TO: ARMA STANDARD, NRC
 FROM: C. F. SANMARCO, ORNL LICENSING
 RE: RESPONSES TO STAFF QUESTIONS ON MODERATOR
 COEFFICIENTS AS USED IN ARMA ANALYSIS

We intend to include the following questions and responses in the next formal ARMA submittal to AEC staff. Should you have any corrections to the questions as written herein, please inform me. We would like to treat these questions/responses with the same weight as given to telephone conference calls.

FROM: C. S. BANWARTH
SUBJ: MATERIAL FOR
11/12 ATWS MEETING

FIGURE 1 - LOFW EVENT TREE

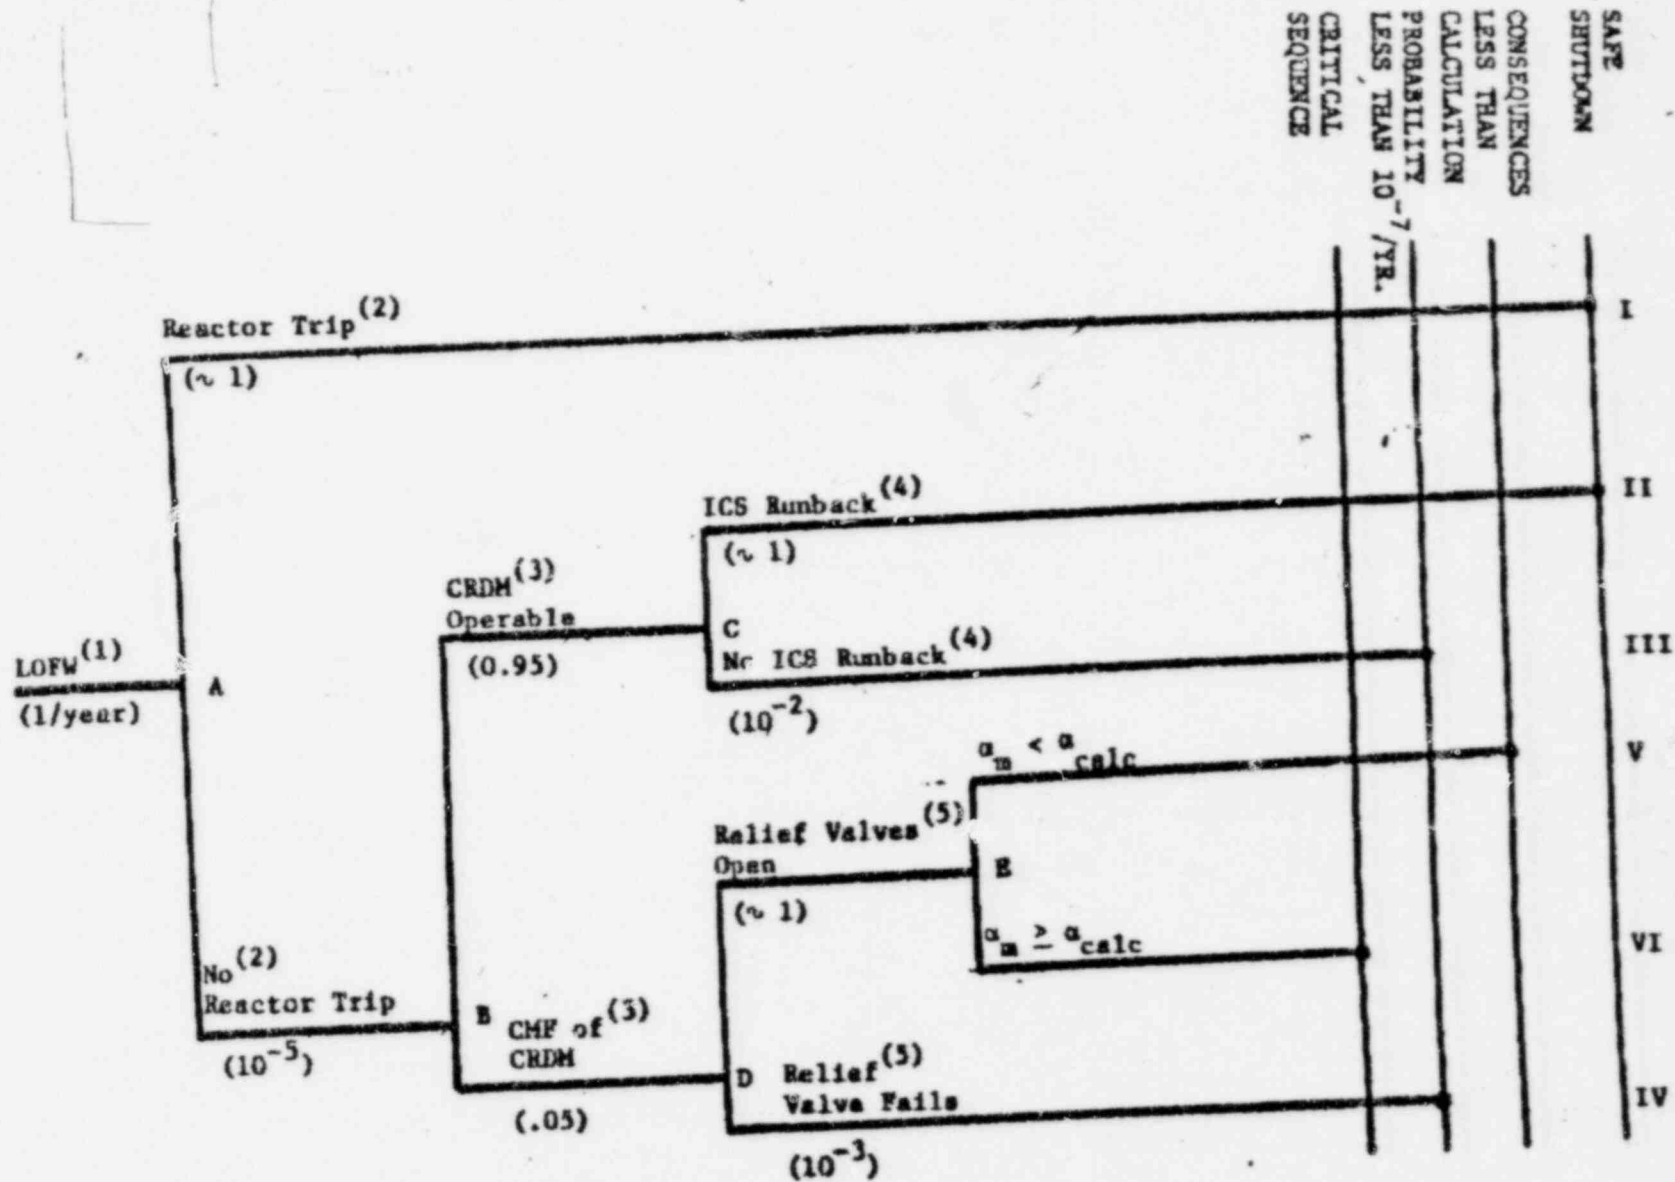
Figure 1 shows the event tree for the sequences initiated by loss of feedwater. Nodal or decision points are labeled with letters. Discussions of specific events are referenced with superscript numerals. Probabilities of specific branches are indicated in parentheses.

The nodal points defining the structure of the event tree are discussed below as keyed to the event tree in Figure 1.

A. Following LOFW, the trip function performs or fails to do so. If trip occurs, plant shutdown with acceptable consequences results. If trip fails, other events must be considered.

B. If trip function fails, either the RPS electronics have malfunctioned in which case the CRDMs are not bound and are not de-energized, or the CRDMs have suffered a mechanical CMF. In the latter case, the RPS has de-energized CRDM stators and ICS runback is discounted.

C. No trip has occurred but the CRDMs are energized and operable. The ICS either runs back three rods or fails to do so. If runback occurs, acceptable consequences result. As will be shown subsequently, the sequence culminating in no runback has probability less than 10^{-7} per year.

D. If trip failure is caused by CRDM failures, either the powered relief valves open or fail to do so. If they open, subsequent events are considered. The probability of the sequence ending with relief valve failure is subsequently shown to be less than 10^{-7} per year.

E. The moderator coefficient, α_m , is either less than or equal to or greater than the value assumed in mechanistic analysis.
